Economic Commission for Europe**Inland Transport Committee****World Forum for Harmonization of Vehicle Regulations****Working Party on Lighting and Light-Signalling****Seventy-eighth session**

Regulations Nos. 37 (Filament lamps), 99 (Gas discharge light sources), 128 (Light emitting diodes light sources) and the Consolidated Resolution on the common specification of light source categories**Proposal for amendment 1 to the original version of the Consolidated Resolution on the common specification of light source categories****Submitted by the expert from the International Automotive Lighting and Light Signalling Expert Group (GTB)***

The text reproduced below was prepared by the expert from GTB to introduce a new light emitting diode (LED) forward lighting light source category L1/6. The proposal is part of a package which also includes amendments to Regulation No. 128. It is based upon the original version of the Consolidated Resolution on the common specification of light source categories (R.E.5) (ECE/TRANS/WP.29/2016/111). The modifications to the existing text of the Resolution are marked in bold for new or strikethrough for deleted characters.

Main Drawing, L1A/6

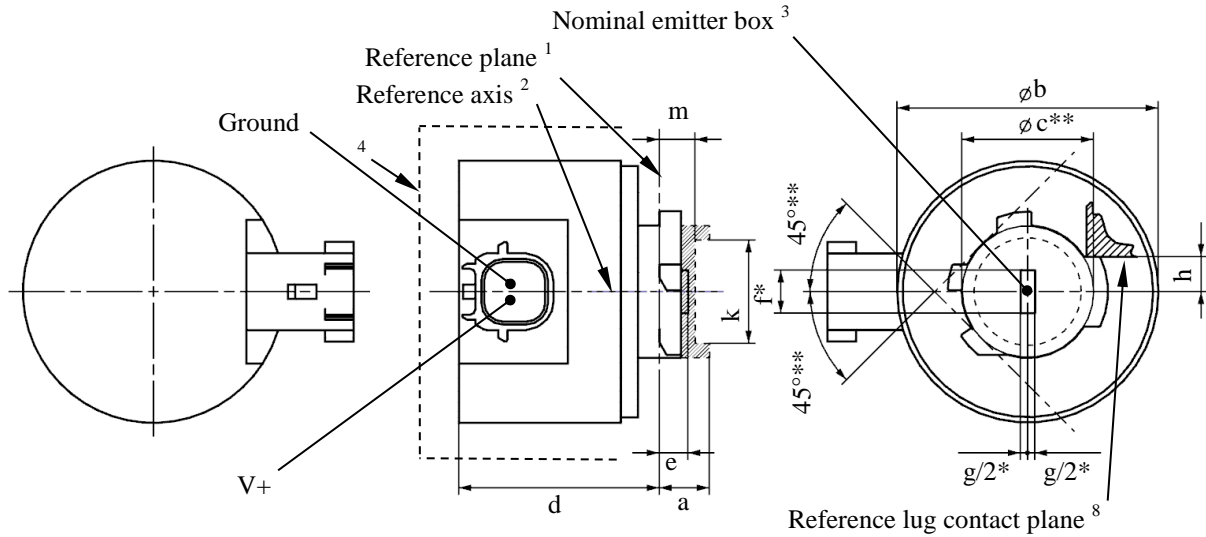
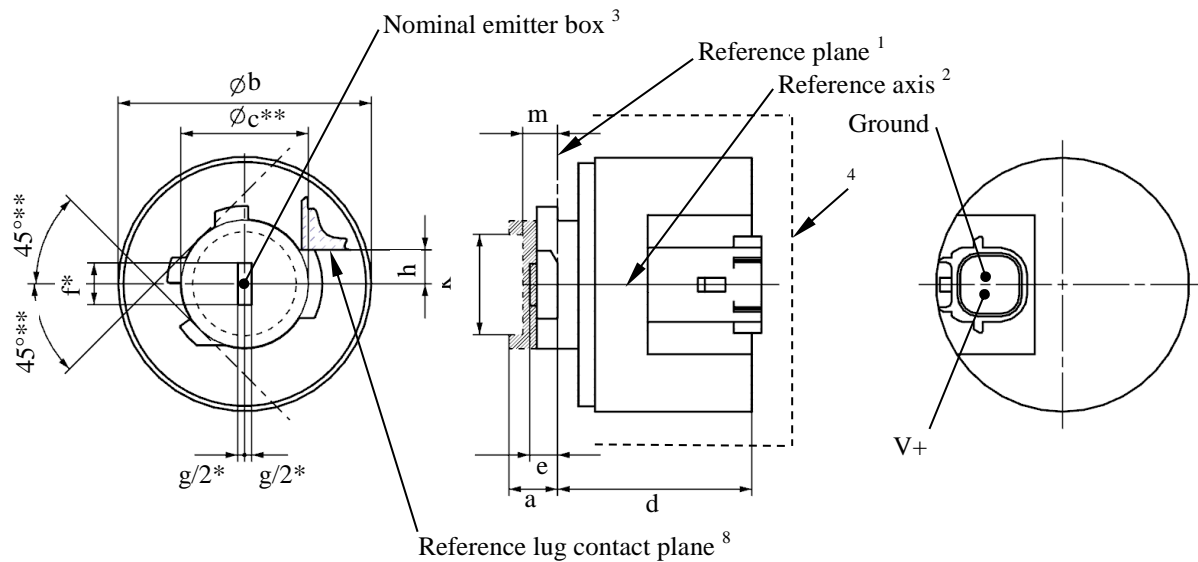
Before sheet LR1/1, insert new sheets L1/1 to 5, to read (see the following pages; one page per sheet):

* Dimensions f and g see table 2.

** Reference system for the emitter box: for detailed dimensions see relevant cap data sheet.

Figure 3

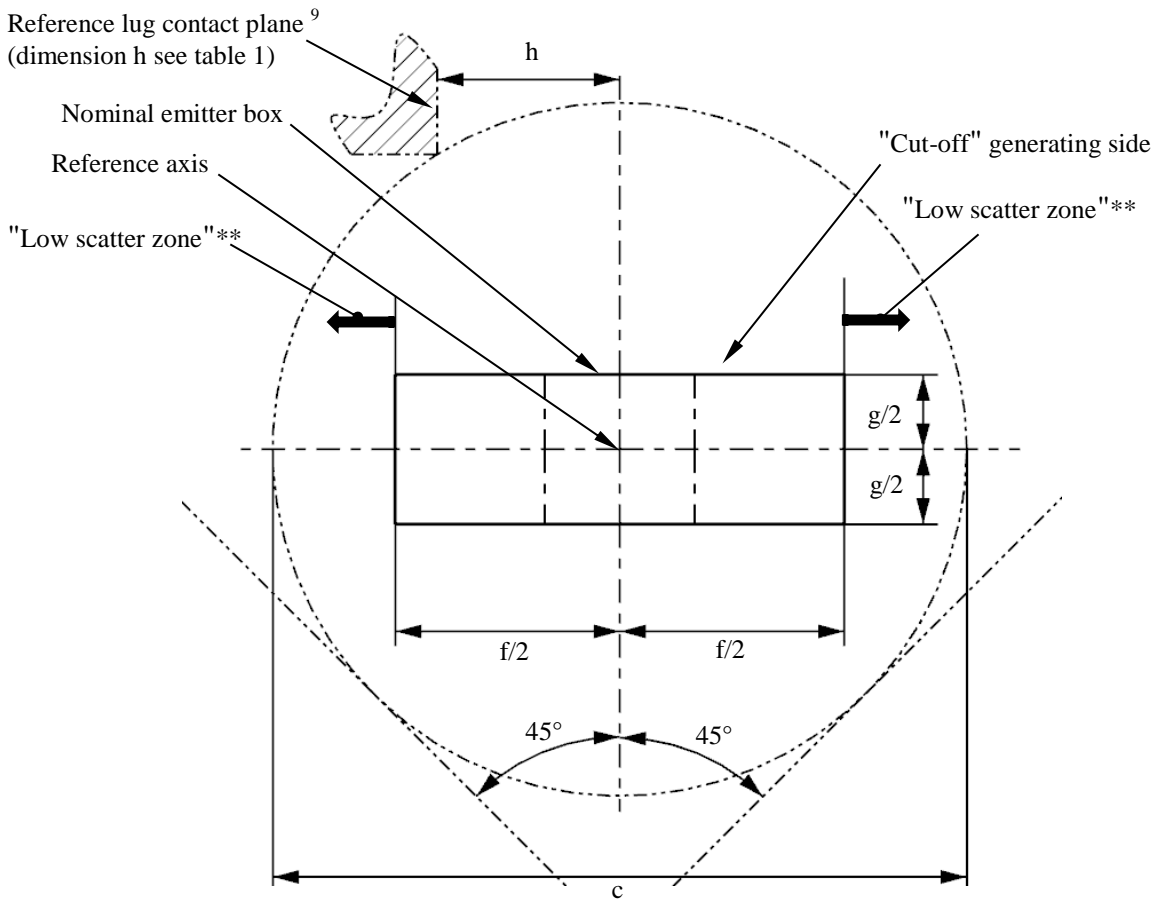
The position, the contrast and the uniformity of the light emitting area are checked by the nominal emitter box system defined in figure 3, which shows the projection when viewing along direction of the reference axis ($\text{Gamma} = 0^\circ$) as defined in Figure 4.

Definition of the nominal emitter box with dimensions as specified in table 2

Figure 4

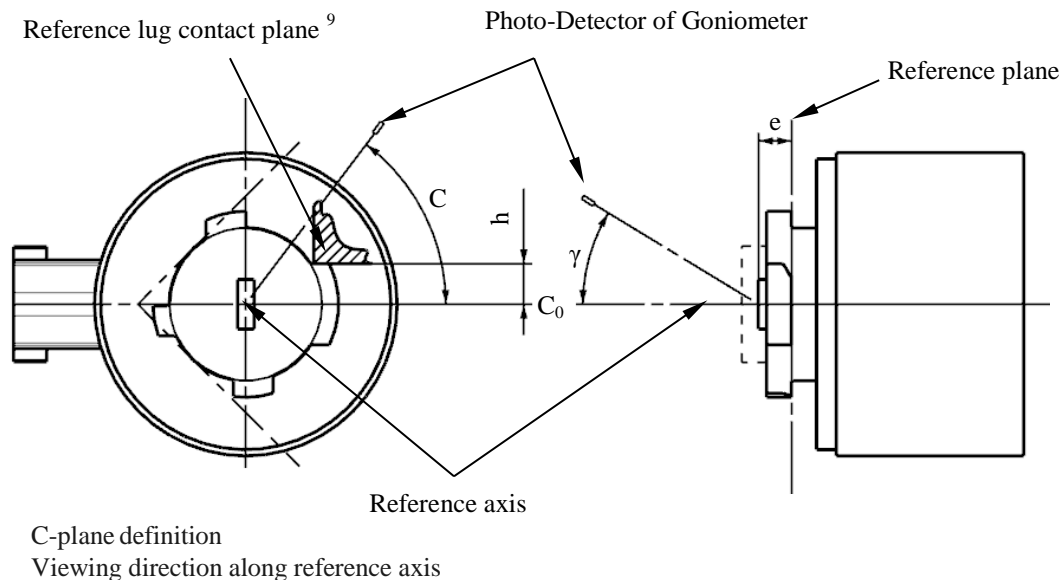
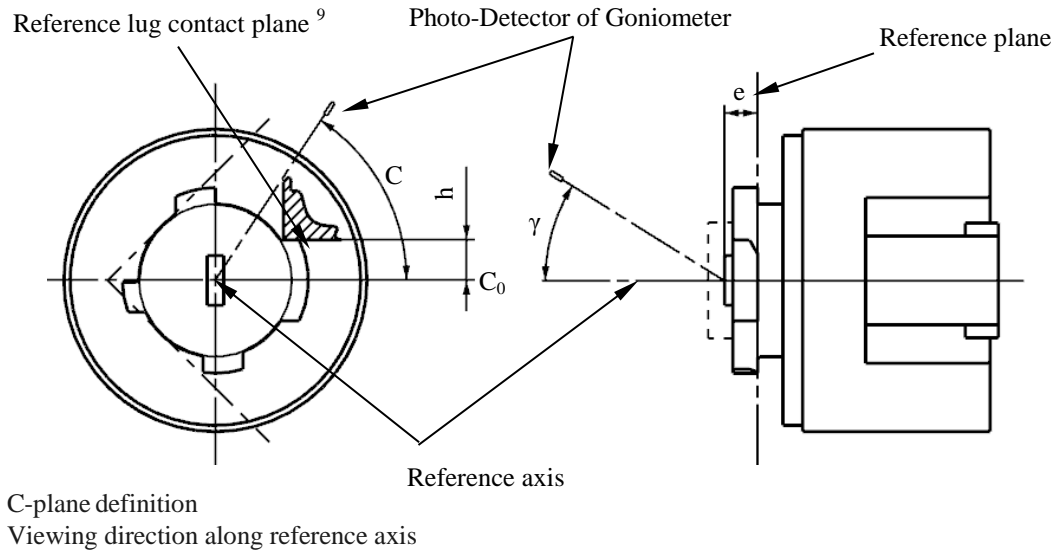
The light source is mounted on a flat plate with the corresponding mounting lug features. The plate is mounted to the goniometer table by a bracket, so that the reference axis of the light set-up is described in Figure 4.

Set-up to measure the luminous intensity distribution for L1A/6

Figure 5
Set-up to measure the luminous intensity distribution for L1B/6
